AP - 082

**GENERAL
CORRESPONDENCE**

From: Griswold, Jim, EMNRD
Sent: Thursday, July 03, 2008 11:17 AM
To: Cliff Brunson (cbrunson@bbciinternational.com)
Subject: AP-82, Hess Corp, Mattern Battery

Regarding the Stage 1 Abatement Plan AP-82 for the Hess Corporation's Texaco Mattern Battery #26 near Monument, I have the following comments/needs:

Pending Soil Boring/Monitoring Well Locations
AP-82: Texaco Mattern Battery #26

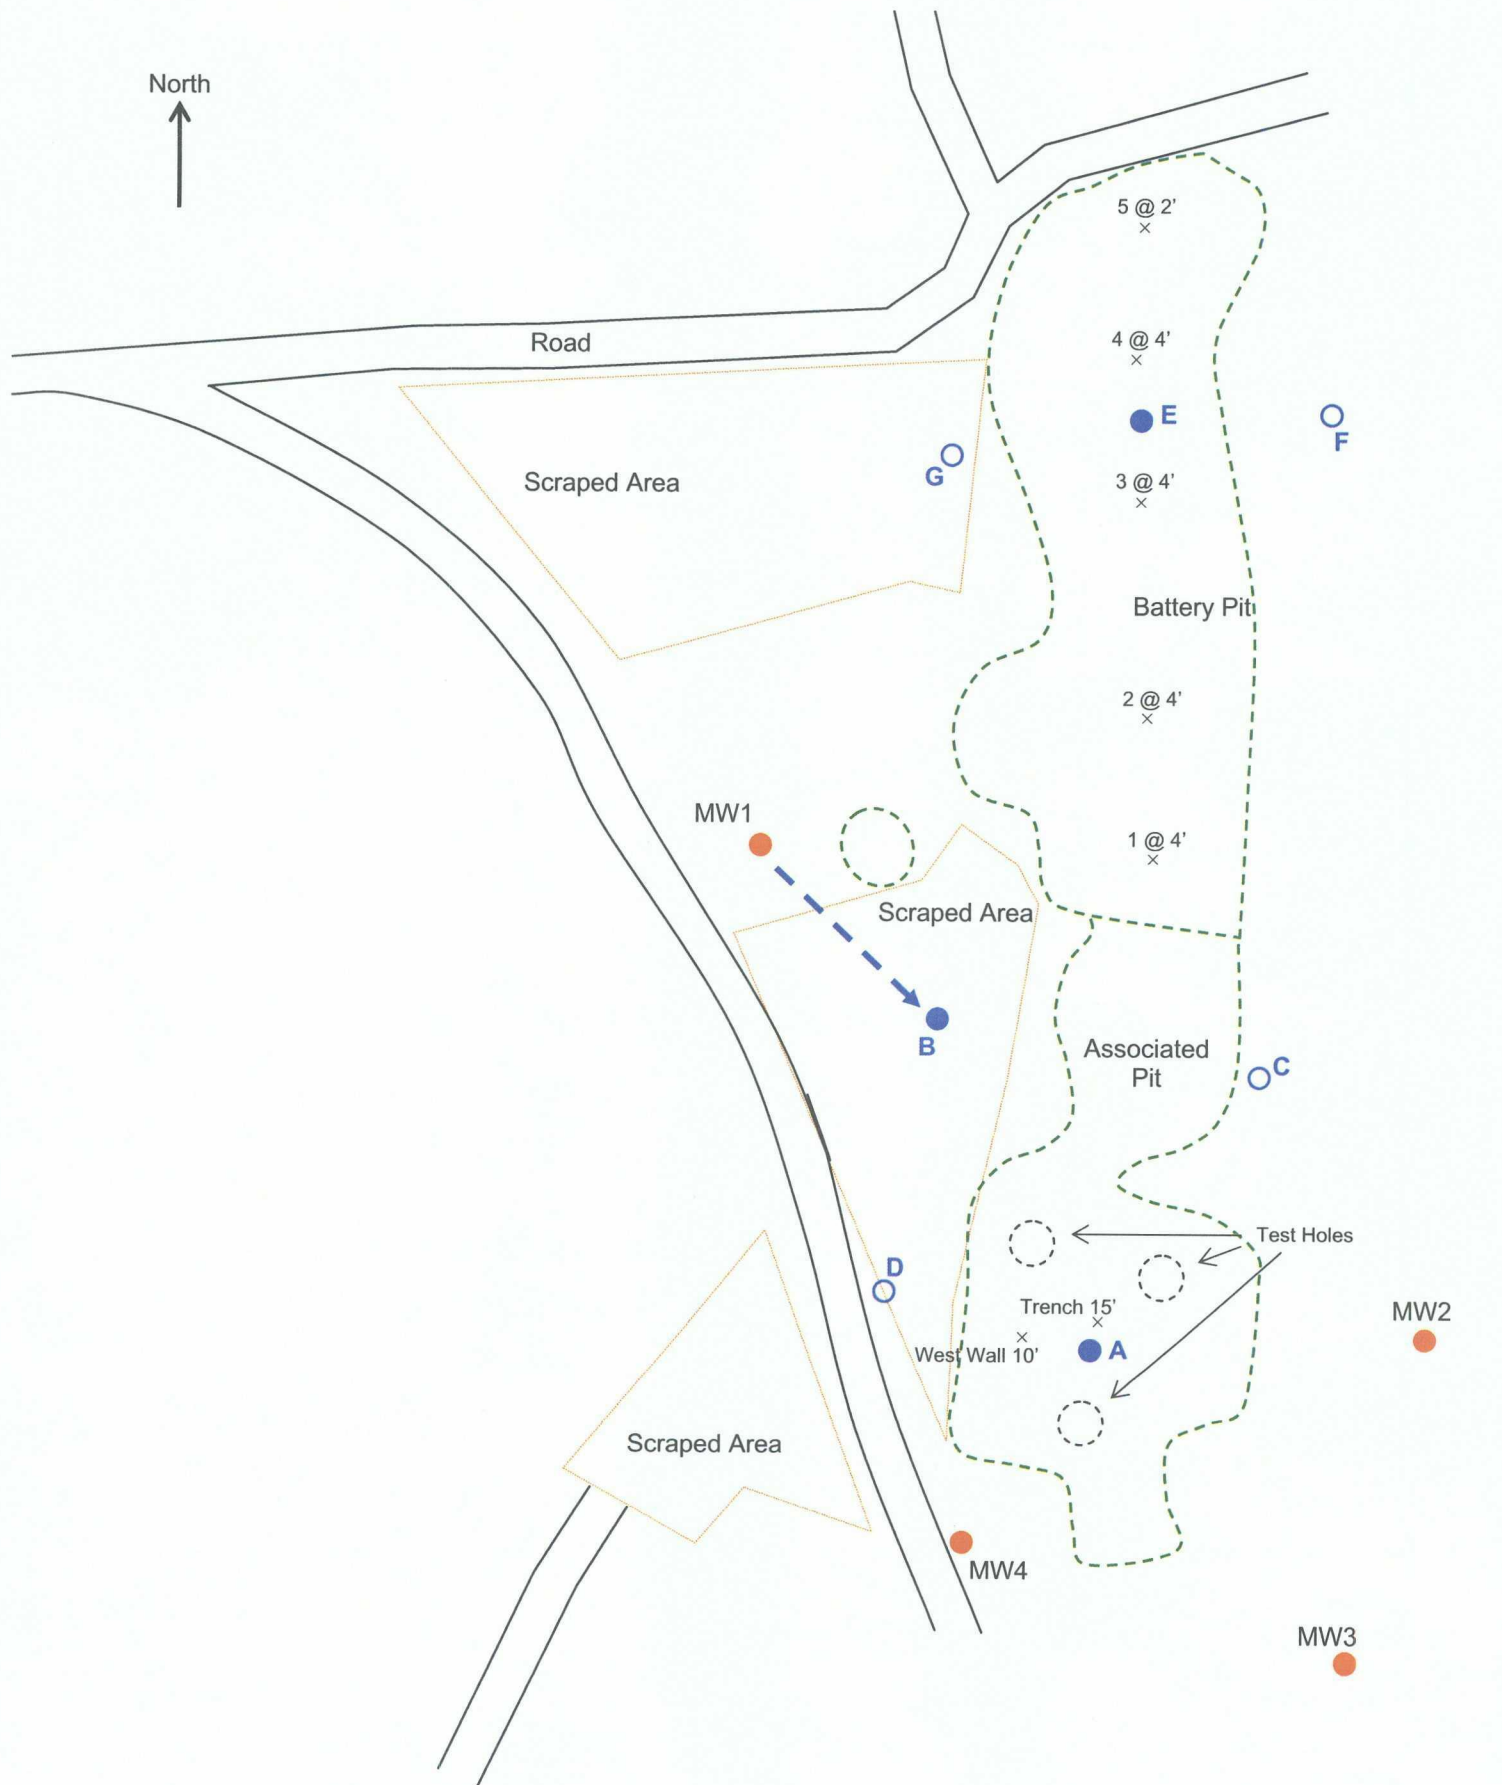
It is stated on page 2 of the plan that the Mattern 3 and 4 samples gathered on 1/3/07 were "...located nearest the former tank pad." I surmise this to mean the tank pad was situated between these locations. Could the former pad be specifically located on future drawings?

Was the green dashed area located just east of your proposed SB1/MW1 location on Figure 3 excavated? If so, why?

What was the reason for the "scraped areas"?

The text discusses a "two foot test hole" advanced in the western floor of the associated pit excavation "...where hydrocarbon stained soils extended deeper." on 1/22/07 when groundwater was encountered. Figure 3 seems to indicate test holes were advanced in three areas, all of which revealed at least a sheen of oil floating atop the water table. Photographs of two of those test holes are provided in Appendix II

A soil boring must be advanced within the area of the associated pit and a groundwater monitoring well must be completed at that location (marked A on the attached figure).

The location of SB-1/MW-1 should be moved nearer the area of likely highest contamination (see location B on the figure).

An additional soil boring should be placed in the area northeast of the associated pit (location C) to assess possible hydrocarbon soil contamination with a goal of delineating TPH to less than 100 ppm. An additional soil boring must be placed in an area west of the pit excavation (location D) based on the data observed from the West Wall sample taken on 1/10/07. Whether or not monitoring wells are installed at either or both of these locations should be made based on field observations.

Due to the concentration of adsorbed chlorides in the soil samples (designated Mattern 3 and 4) taken at shallow depths near the former tank pad, an additional soil boring/monitoring well must be installed in that area (location E). Soil borings should also be advanced in areas east and west (locations F and G) of this location with a goal of delineating the concentration of chloride in soil to less than 250 ppm. This may necessitate the installation of monitoring wells in those lateral areas.
